# MINUTES

## COUNCIL MEETING

### 2.1. Amendment C339ggee Flood Zones and Overlays - Review of Complex Submissions - Lara, Avalon and Fyansford

Amendment C339ggee Flood zones and overlays – Review of Complex Submissions - Summary and Response Table July 2022

Figure 20 Lara Central, Lara Lakes and Applegum developments and Exhibited Overlays

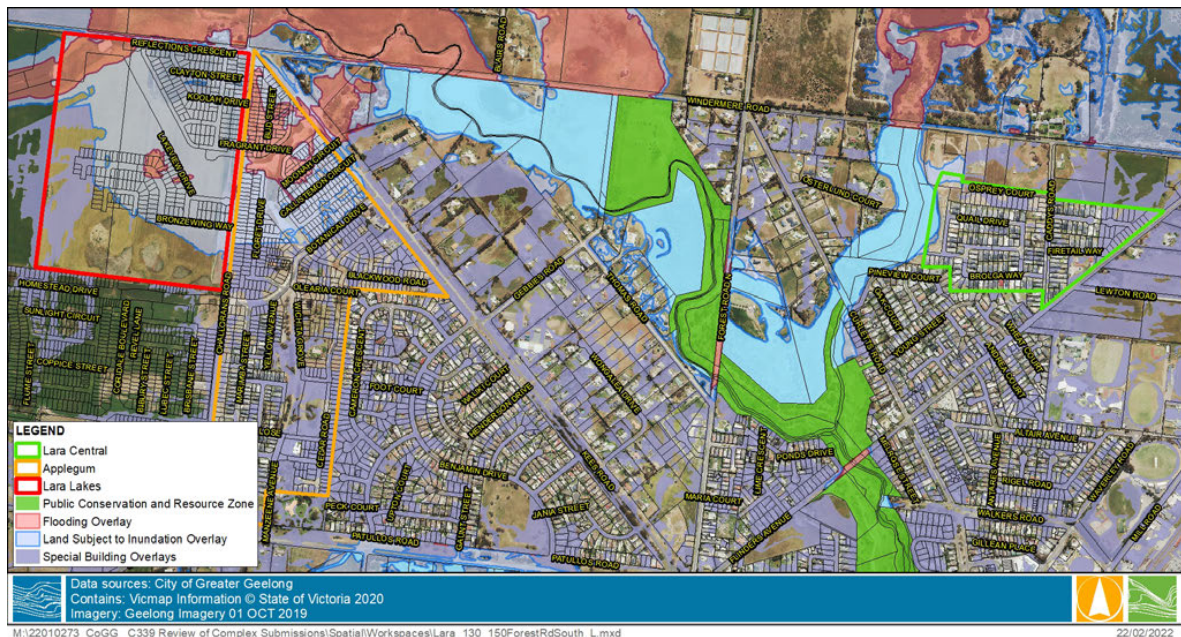
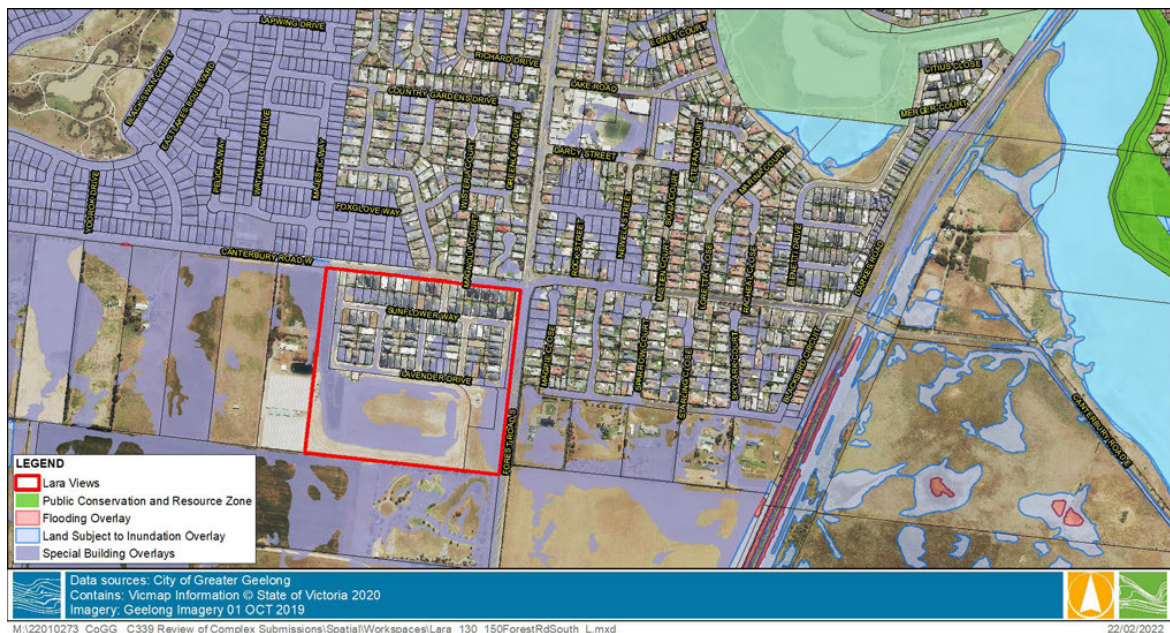
The following response is in relation to submission 296, located at the following locations listed below and shown in Figure 19 & Figure 20.

- 130-150 Forest Rd South (Lara Views Estate)
- 385 Windemere Road (Lara Lakes Estate)
- 43-55 & 60 Manzeene Avenue (Applegum Subdivision)
- 21 Caddys Road, 131 Flinders Avenue & 135 Flinders Lane (Lara Central Estate)

**Figure 22** Area to be omitted

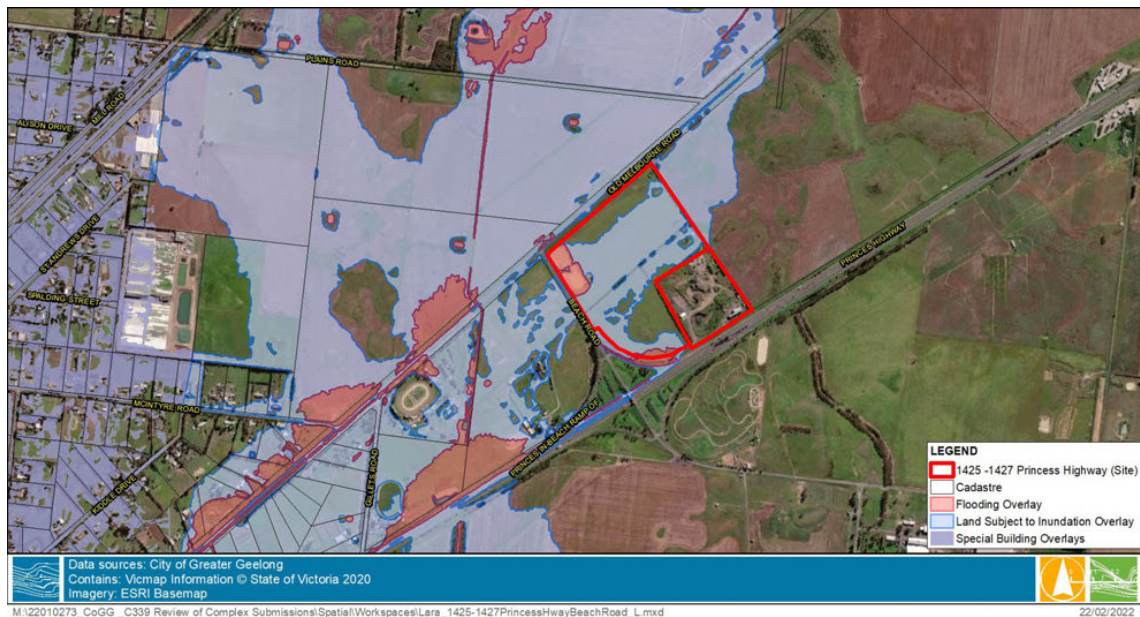
The areas to be omitted from the current amendment are shown in Figure 22 below.

Figure 25 1973 Flood Imagery (post-event) at site

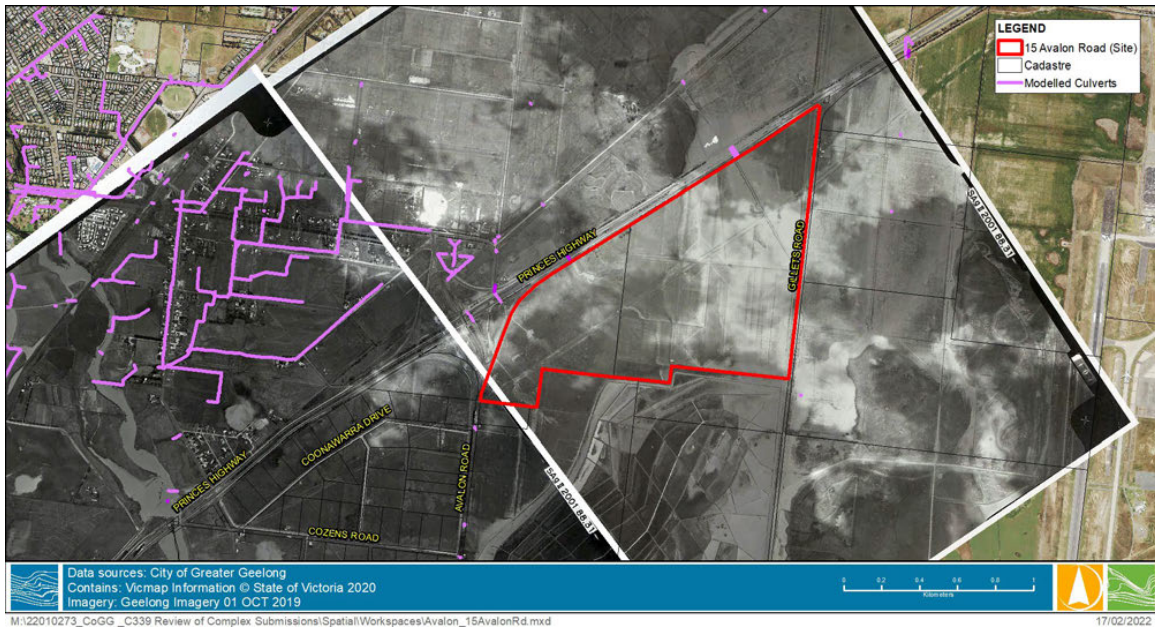
Until the sensitivity modelling has been completed, there is likely uncertainty around the impact of the 1% AEP flood extent and as a result the planning overlays exhibited.

Figure 30 Flood Level Difference (1% AEP 48hr) Existing vs Revised

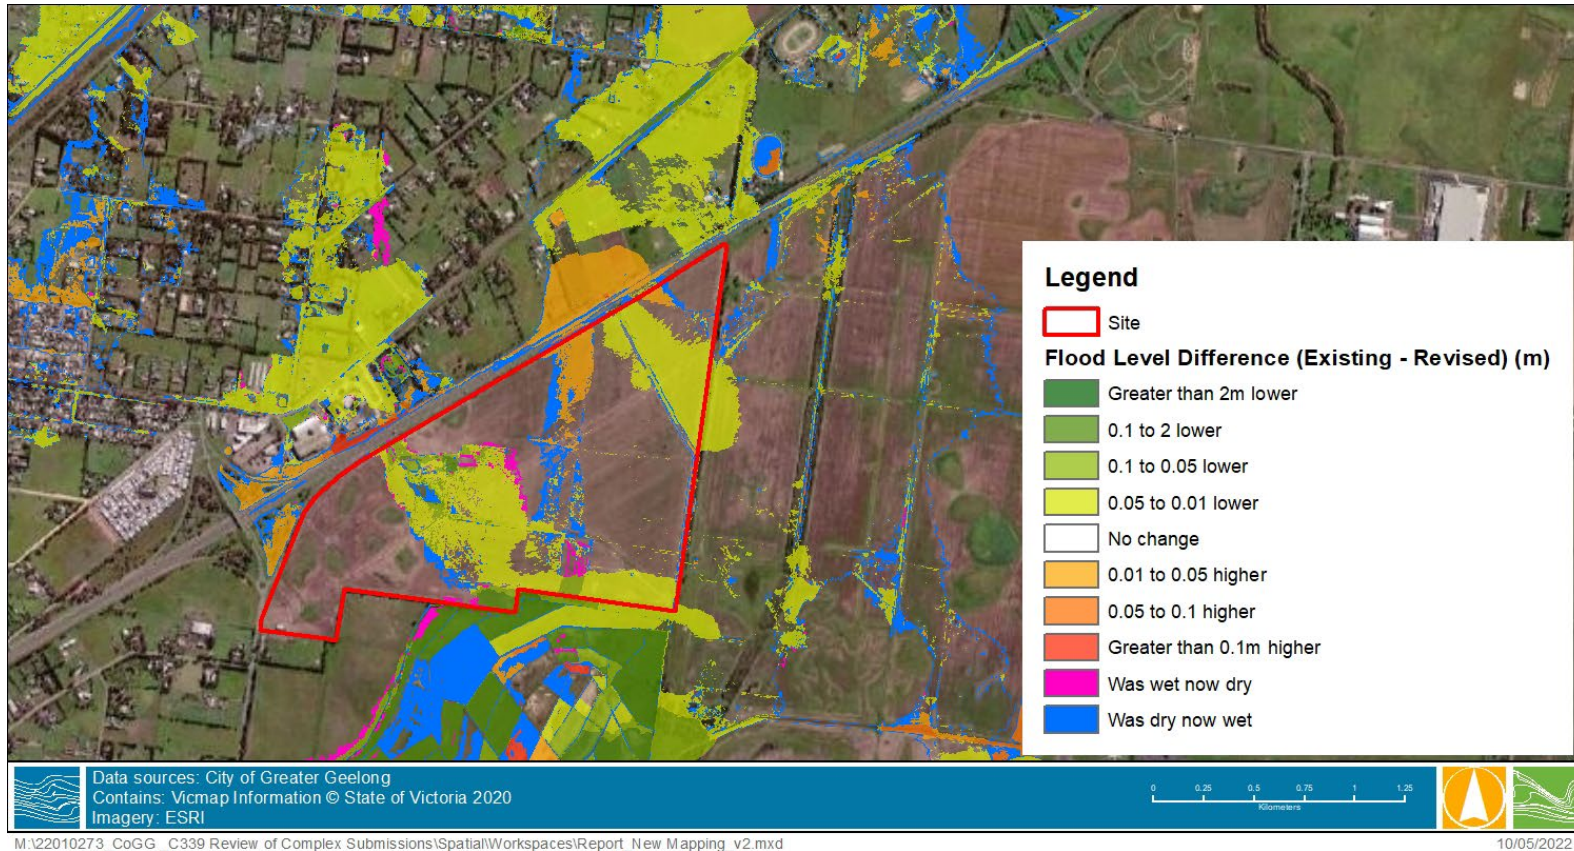
The maximum flood depth results of the updated model have been compared to the previous results from the Lara Flood Study. The assessment indicated a minor change in flooding extent at the location of the northern crossing. Under both scenarios the Princes Highway is overtopped in the 1% AEP flood event. Whilst the capacity of the culverts has changed this has resulted in an increase in flood levels upstream of the highway leading to an increase in water overtopping the road as shown in Figure 6-28. Flood Levels upstream and downstream of the highway adjacent to the northern culverts are shown in the Table below:

Figure 31 Sub Catchment and Inflow Locations

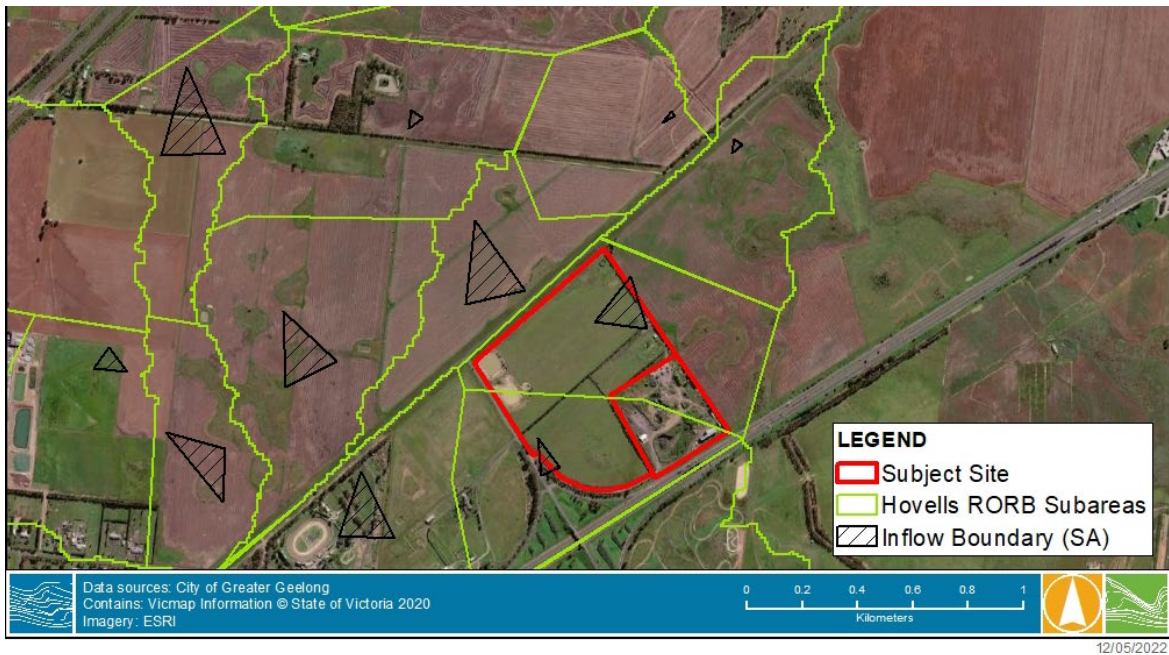
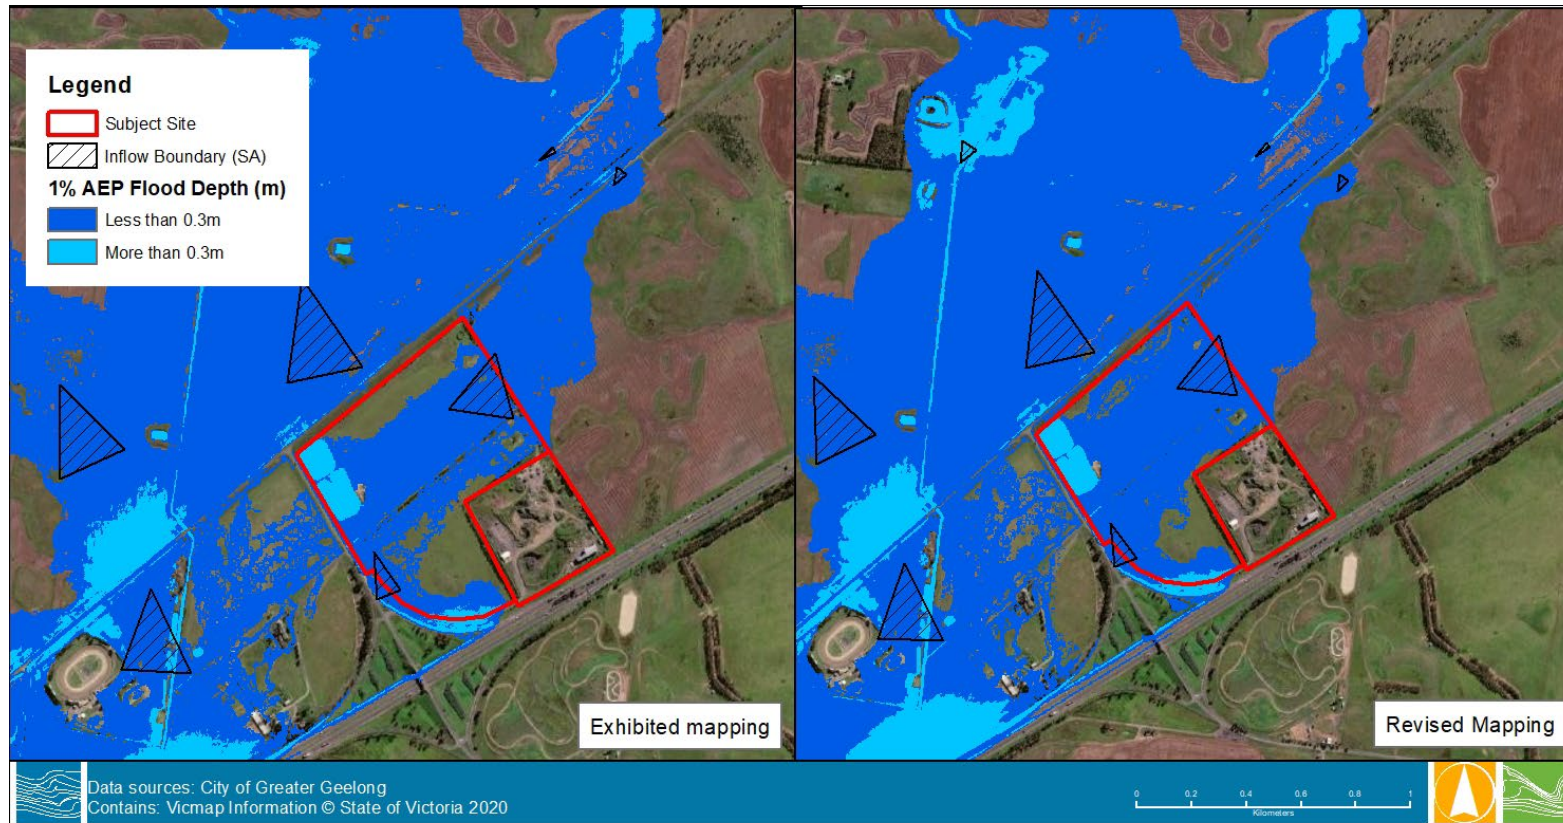
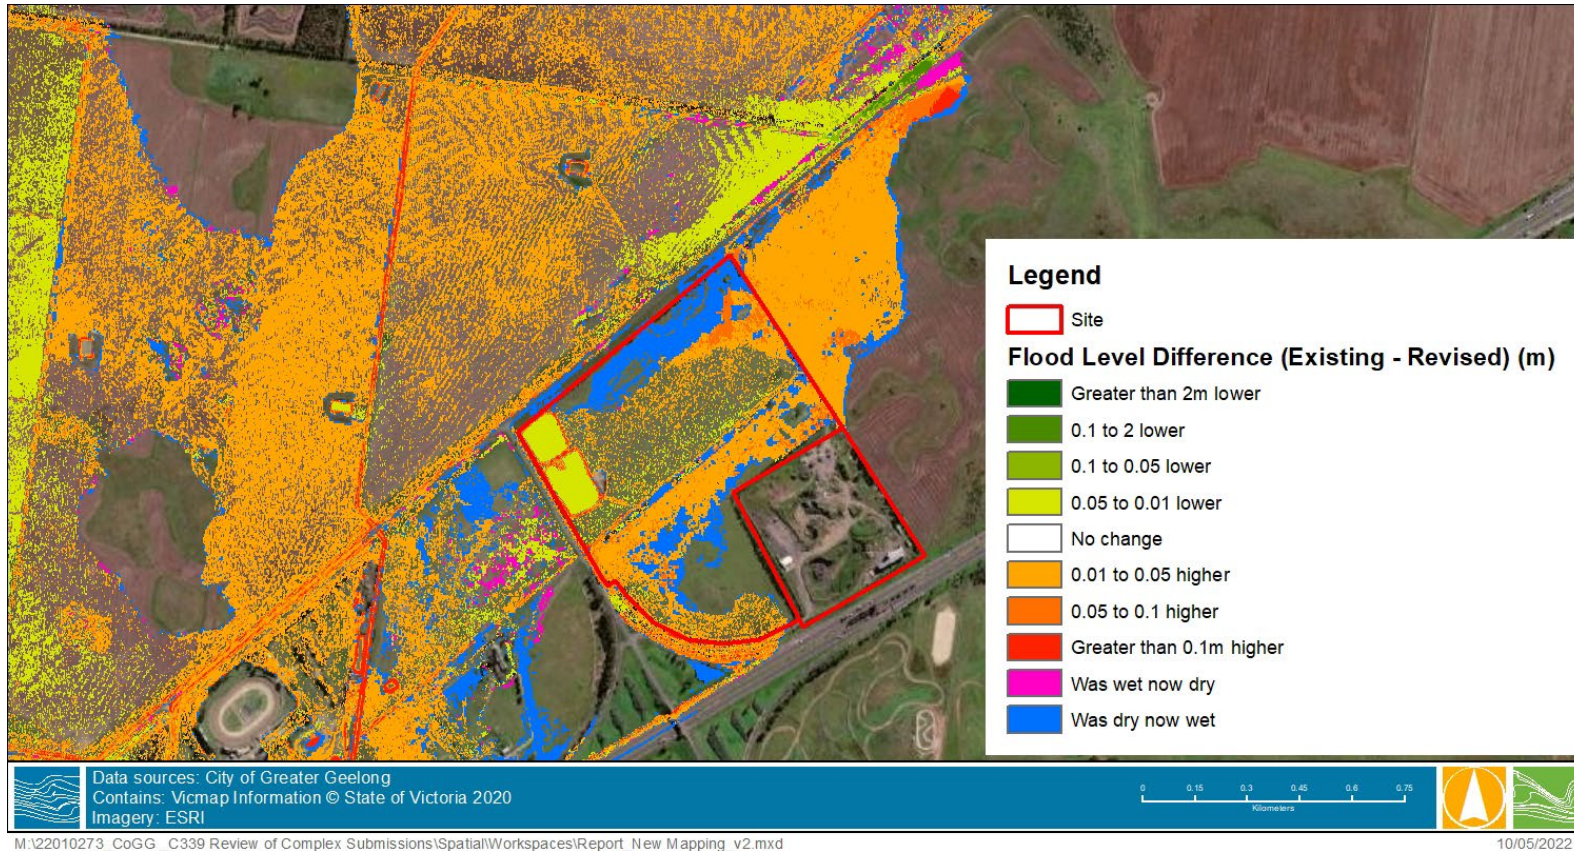
- Relocation of existing inflow boundary (SA) from on top of the Old Melbourne Road to immediately downstream of the highway. This movement of this inflow boundary is in line with the catchment delineation assessment undertaken as part of the Lara Flood Study RORB modelling which covers this location. The comparative locations of these inflows are shown in Figure 31.
- Model in TUFLOW HPC with Sub Grid Sampling at 1 meter grid resolution which allows for greater representation of narrower channels and capacity within the rural drainage network and storages onsite.

The results of the revised flood mapping are shown in Figure 31. The flood depth results indicate an increase in the flooding extent onsite associated with the changes to the model. The flooding extent has increased within the northern portion of the site adjacent to Old Melbourne Road. Flooding depths within this area of increased extent are between 1-3 cm. This is predominantly associated with the inflow now being located on the downstream side of the Old Melbourne Road culverts which is inputting more water into the model immediately upstream of the site.

Based on the results of the revised mapping indicating an increase in flooding extent with very shallow depths it is recommended that the **flood overlays at this location are applied as exhibited**.

Figure 34 Properties within NGA with Exhibited Overlays

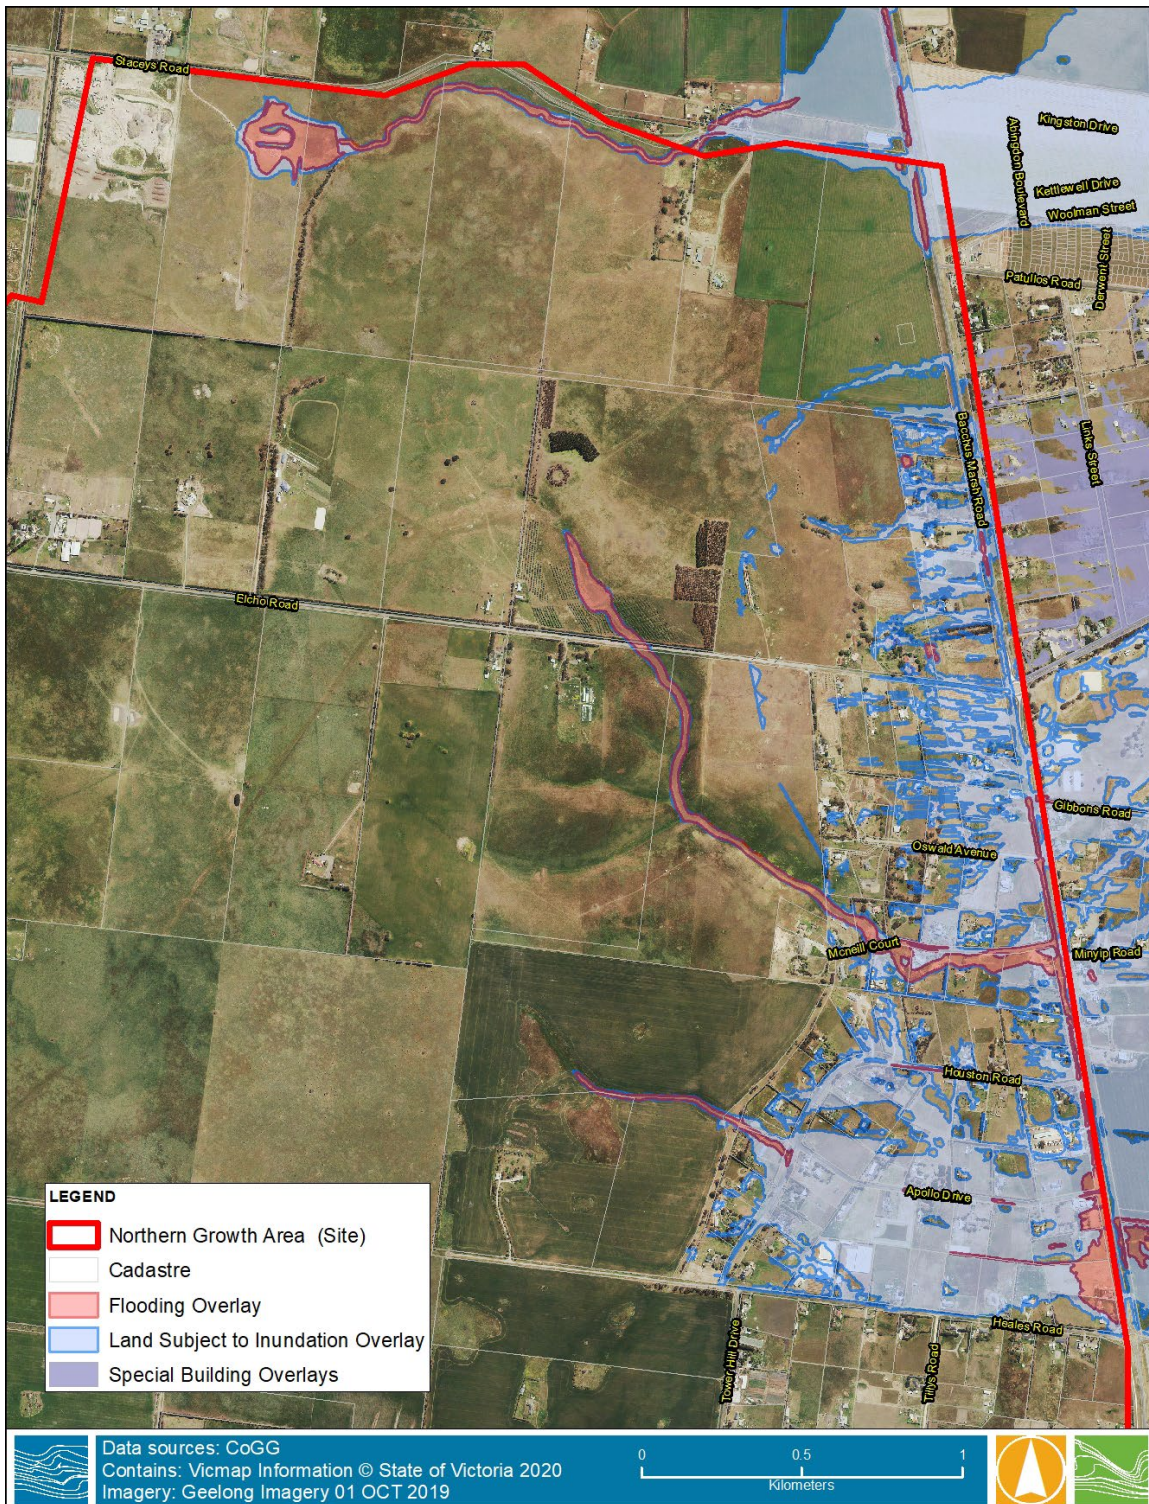
While it is understood that Lovely Banks are undertaking significant planning works in relation to the future development of their site, it should not be expected to preclude the exhibited overlays from being included within the current amendment. The Elcho Road PSP work is relatively high level and would not likely provide the 'best available' flood information for the current conditions. There are a number of existing properties within the NGA that have been identified as being at risk from flooding (Figure 25). Exclusion of the NGA and these properties could leave the City liable by not providing the most up to date and 'best available' flood information as part of the amendment.

As timelines for the NGA works have not been finalised and considerable design work still to be completed it is recommended that proposed overlays are excluded for this area with Amendment C339. Future adjustments to flood overlays associated with PSP investigations could be implemented at a later date as separate amendments.
